SOLICITATION AMENDMENT
MODIFICATION DE L'INVITATION

Title - Sujet Services for Floating refit	
Solicitation No. - N° de l'invitation F2599-135004/A	Amendment No. - N° modif. 005
Client Reference No. - N° de référence du client F2599-135004	Date 2013-06-12
GETS Reference No. - N° de référence de SEAG PW-\$\$MD-028-23736	
File No. - N° de dossier 028md.F2599-135004	CCC No./N° CCC - FMS No./N° VME
Solicitation Closes - L'invitation prend fin at - à 02:00 PM on - le 2013-06-20	Time Zone Fuseau horaire Eastern Daylight Saving Time EDT
F.O.B. - F.A.B. Plant-Usine: <input type="checkbox"/> Destination: <input type="checkbox"/> Other-Autre: <input type="checkbox"/>	
Address Enquiries to: - Adresser toutes questions à: Byron, Dan	Buyer Id - Id de l'acheteur 028md
Telephone No. - N° de téléphone (819) 956-0691 ()	FAX No. - N° de FAX (819) 956-0897
Destination - of Goods, Services, and Construction: Destination - des biens, services et construction:

Solicitation Amendment #5 is issued to:

DWG# G05-ESSENTIAL

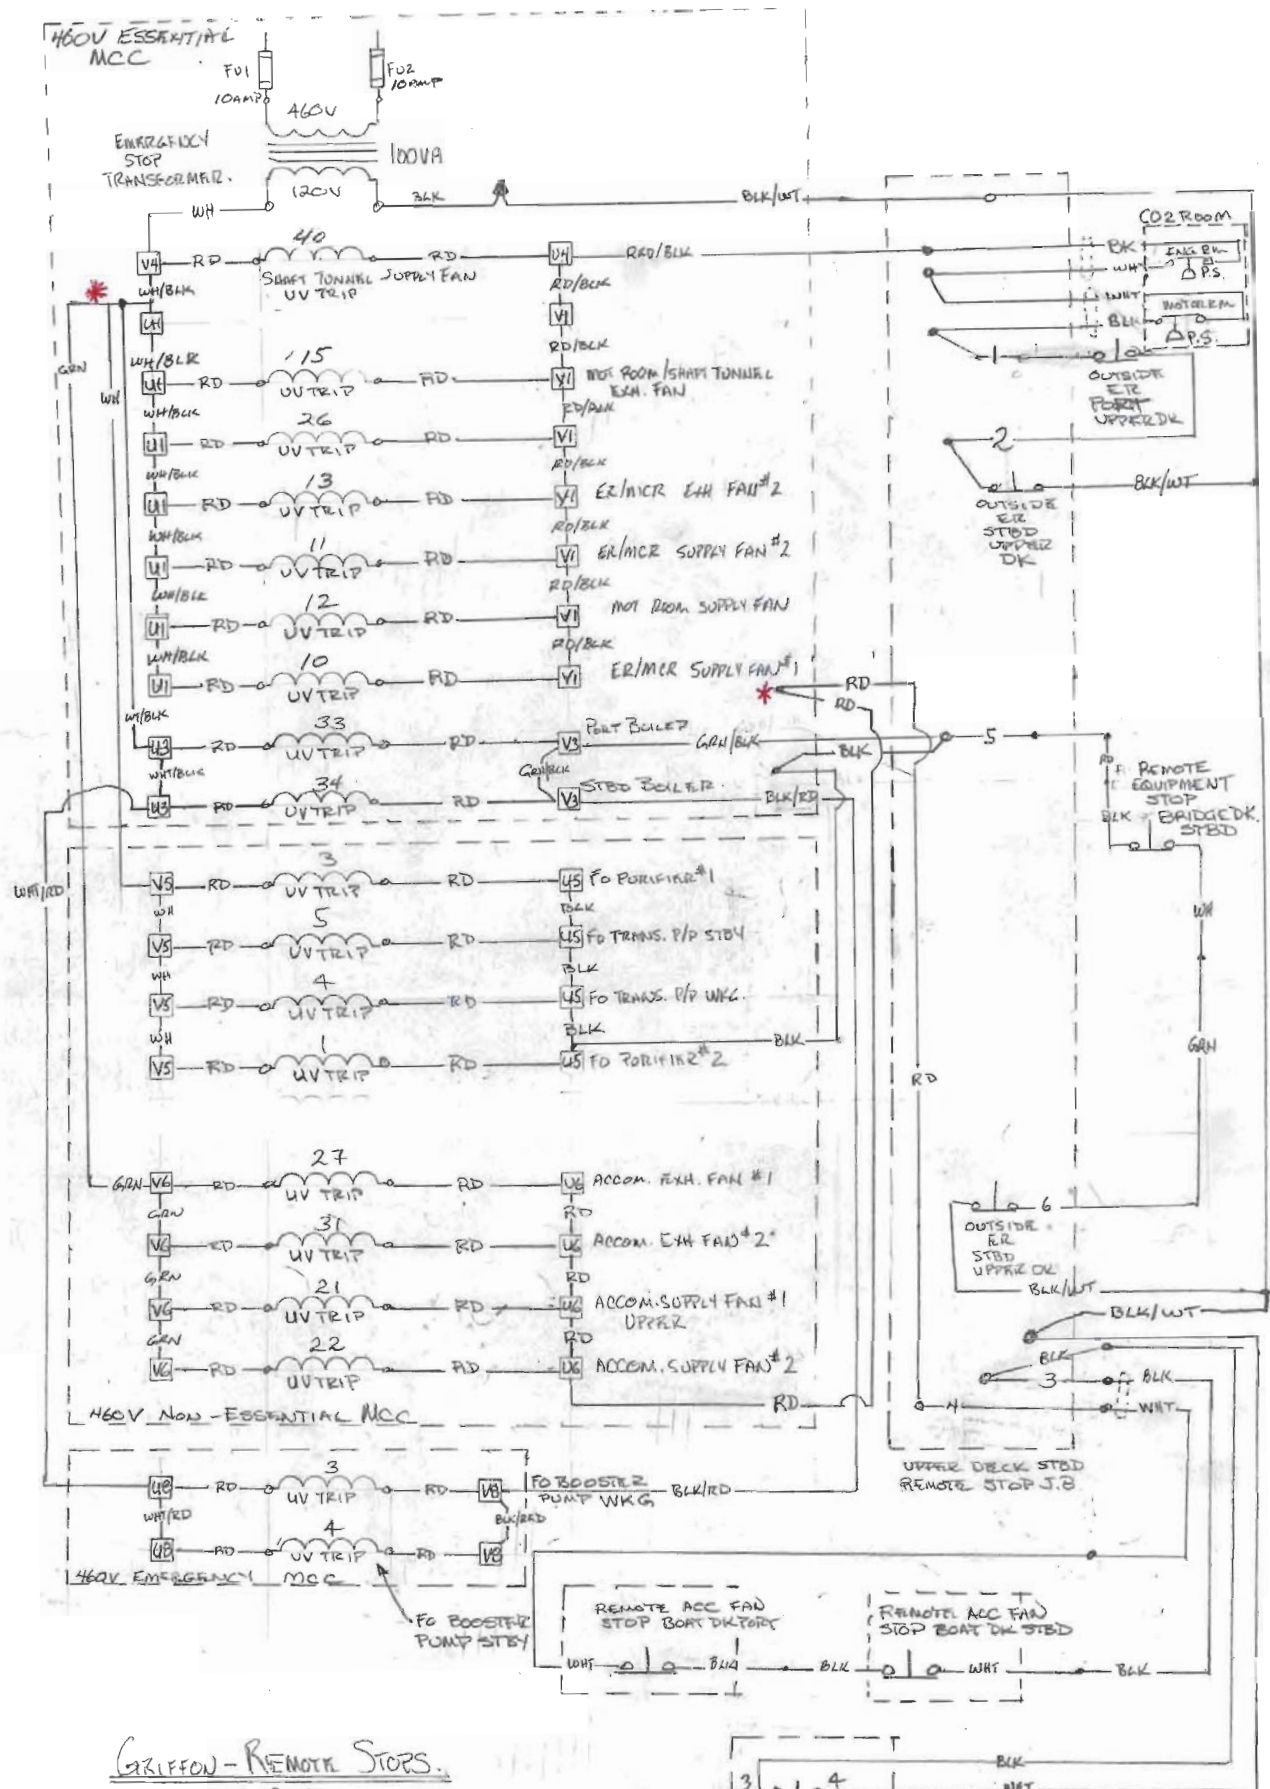
12) Include drawings G05-ESSMCC.PDF and Griffon Remote Stop Schematic.pdf to the drawing package

drawings G05-ESSMCC.PDF and Griffon Remote Stop Schematic.pdf to the drawing package

13.6.4.3.11 The Contractor shall supply and install a new circuit breaker to supply the new AHU. This circuit breaker to be similar ratings to the one fitted C.B. in Panel 54-P-2, but fitted with an under voltage trip. The U.V. trip to be 120 VAC and connect this coil to the existing accommodation vent trip circuit located inside the MCR.

13.7.5 The Contractor shall coordinate inspection by TCMS and work with TA to demonstrate remote shut down of the new installation.
